# Agenda

## **Planning Committee Meeting Thursday 6 April 2017**

**Applicant:** Raynk Investments Pty Ltd  
**Owner:** Mr Frank H Yates & Mrs Rhonda A Yates  
**Location:** Lot 678 DP 257438 No. 63-71 Sexton Hill Drive, Banora Point  
**Zoning:** R2 - Low Density Residential  
**Cost:** \$1,500,000

**Amended proposal – six townhouse development and increased rear setback to 4.037m.**

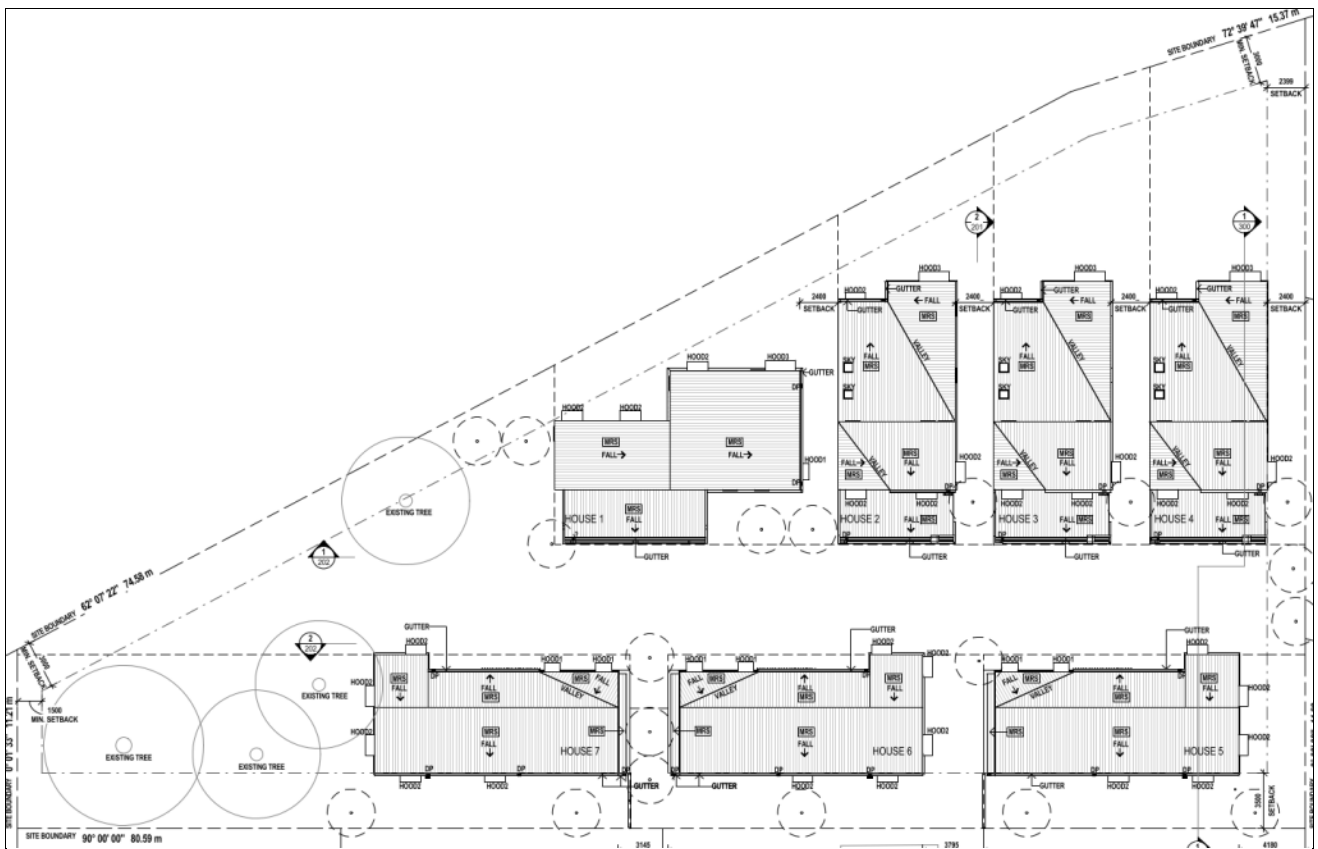
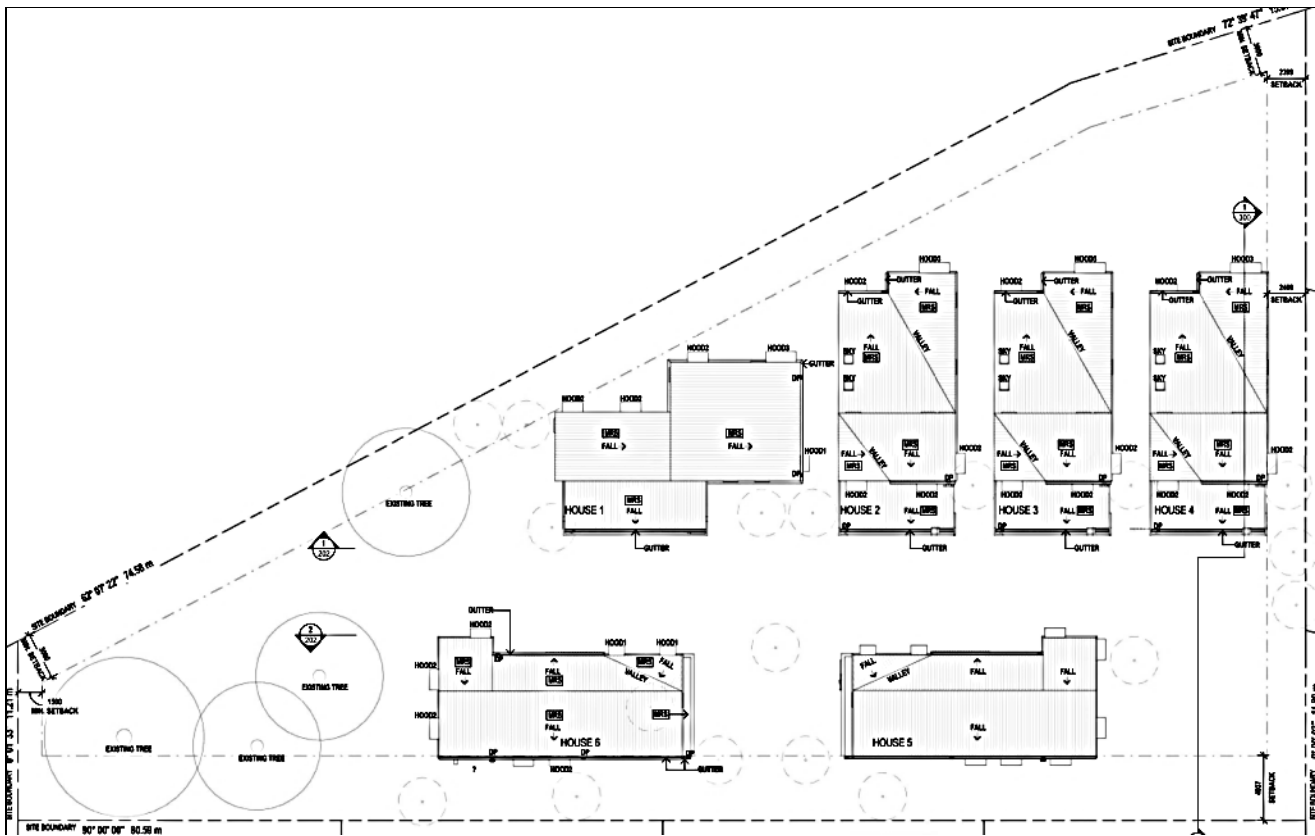
The applicant originally sought approval for a seven townhouse development, however one townhouse located at the rear of the site has been removed therefore the amended application seeks Council consent for a six townhouse development and six lot strata subdivision.

**Original proposal - seven townhouse development 3.5m rear setback.**

### **Section A1- Part B - Chapter 2 Design Control - Site Configuration - Topography Cut & Fill - Control H**

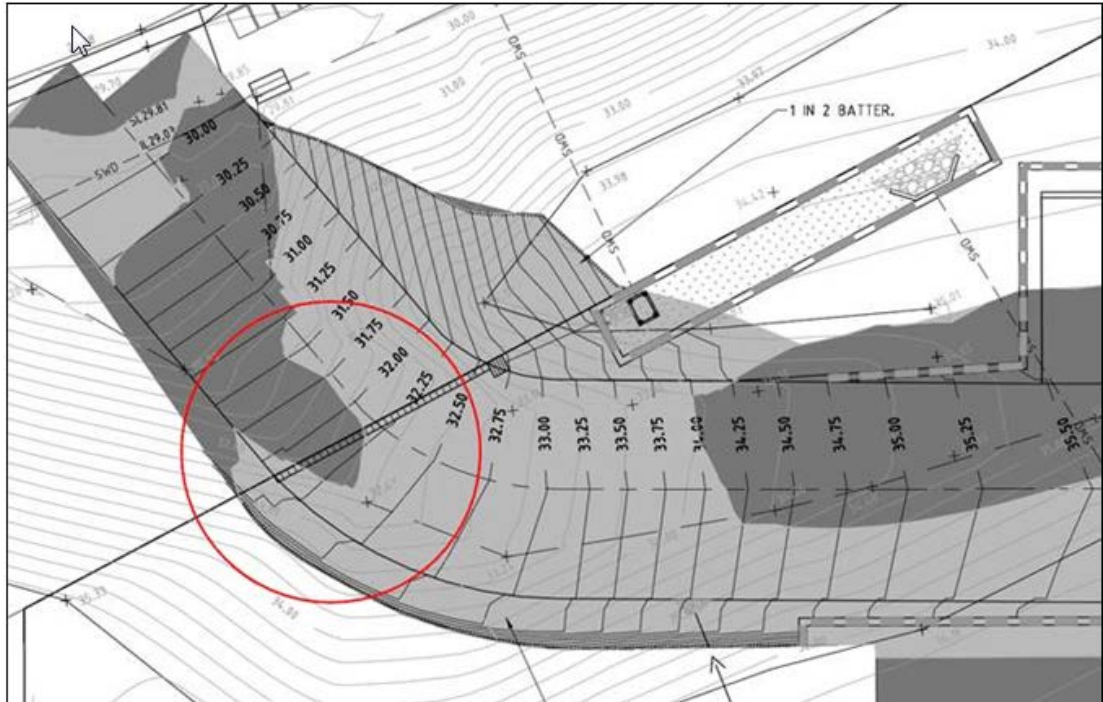
The proposed development does not meet control H relating to the maximum level of cut and setback requirements for fill.

The area of noncompliance relates to proposed fill to enable improved access to the site, refer to figure below.

The applicant states that cut and fill is proposed along the front boundary (driveway access) and therefore does not comply with the standard. Refer to the cut and fill plan above. Cut and fill appears to be minor but also required to provide improved access, with all other cut and fill is within the confines of the building footprint or internal access and parking. The proposed variation is minor and is due to the strict interpretation to the control. It is considered that the earthworks are unlikely to create an impact on the natural or built environments. However the following comments are made in relation to the objectives.

**Figure illustrating the front setback variation which effects the visitor car space.**

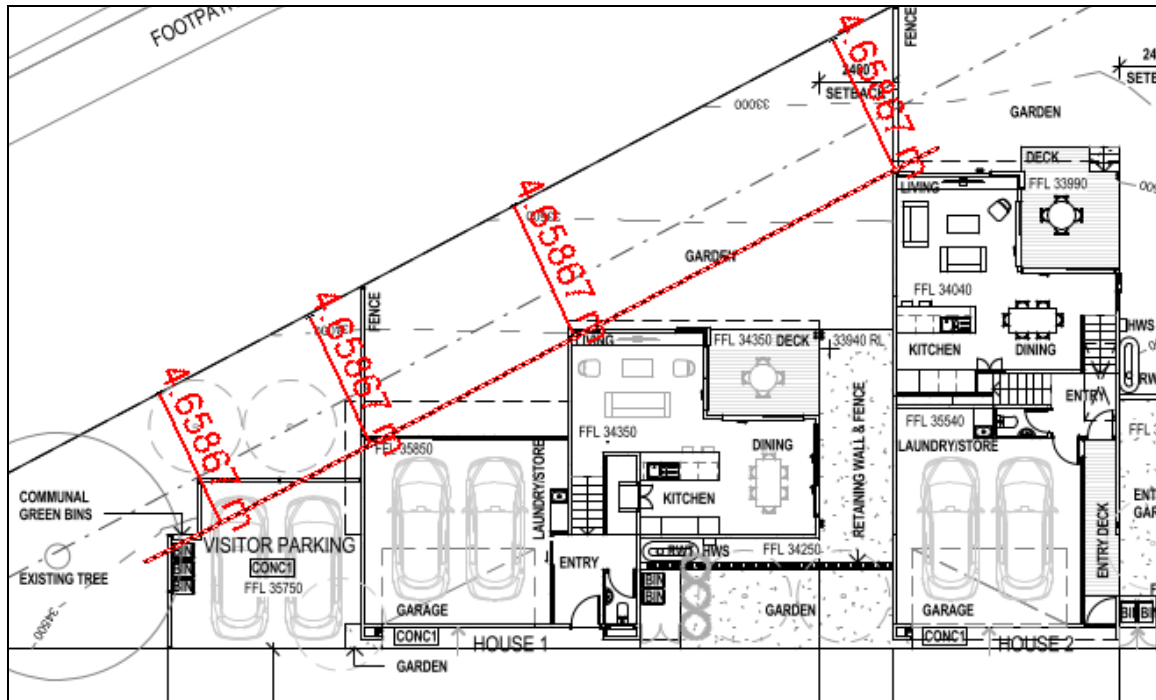
A setback of 6 metres is the development control, however, as the site is an infill site the average setback plus or minus 1m can be applied. Therefore the infill setback could be reduced to 4.65m. The development proposes a small variation relating to the visitor car parking space, refer to figure below illustrating the 4.65m setback and variation.

The proposed front setback variation is supported, as the variation will not impact on the streetscape as the buildings will not be visible from the Sexton Hill Drive. The site is elevated above Sexton Hill Drive which is vegetated therefore the variation will not be visible or impact on the street edge. The site has a large setback from the property boundary to the road edge being 11.8 metres, which contains vegetation, refer to figure below.

**Figure illustrating landscape intent - please note that this plan relates to the original proposal for seven townhouses.**

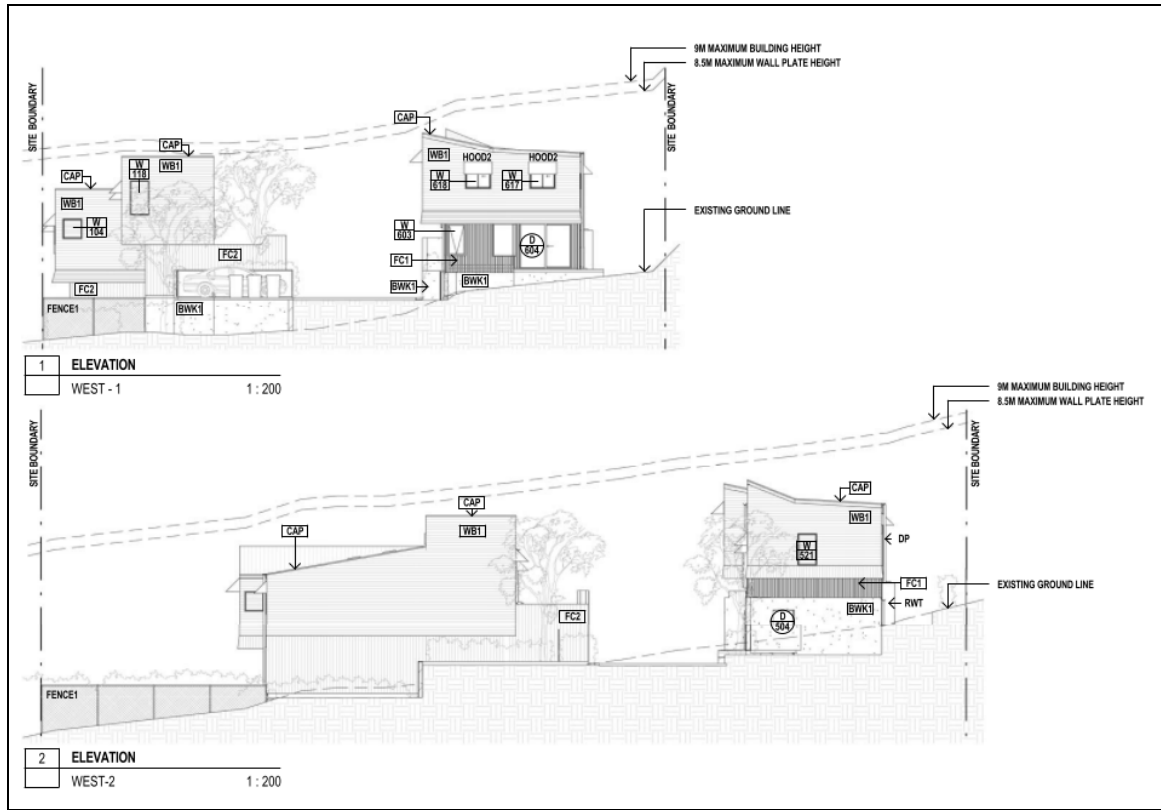
The proposed variation is supported as the variation will not impact on the residential properties located at the rear of the site, not impact on the transition between public and private space. Adequate space is provided on the rear property boundary for landscaping, refer to landscape intent plan below.

Due to the topography of the site being lower than the properties to the south and the proposed cut, the proposal is considered to less of a visual and privacy impact than if the site were level. The site level difference combined with rear fencing and the setback of the existing residential dwellings combine to assist in

reducing visual and privacy impacts and support the variation of 1m for the two town houses (numbered 5 and 6) located on the rear southern boundary.

**Figure illustrating view from the south.**

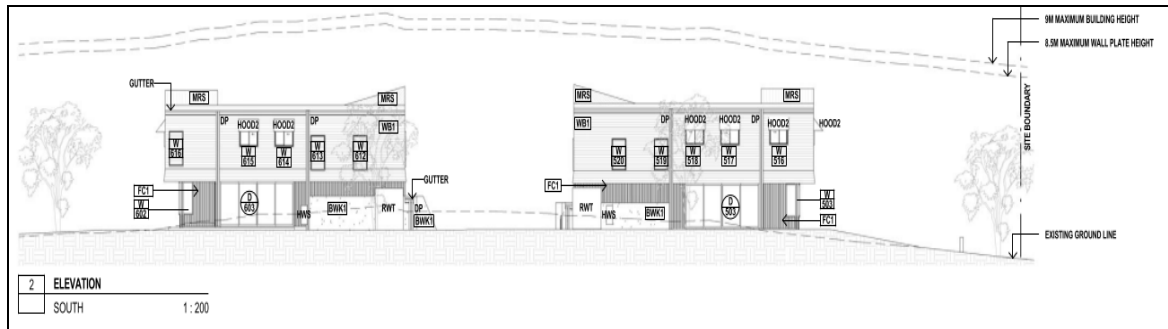
**Figure illustrating the rear setback and topography of the subject site and neighbouring property to the rear (south).**
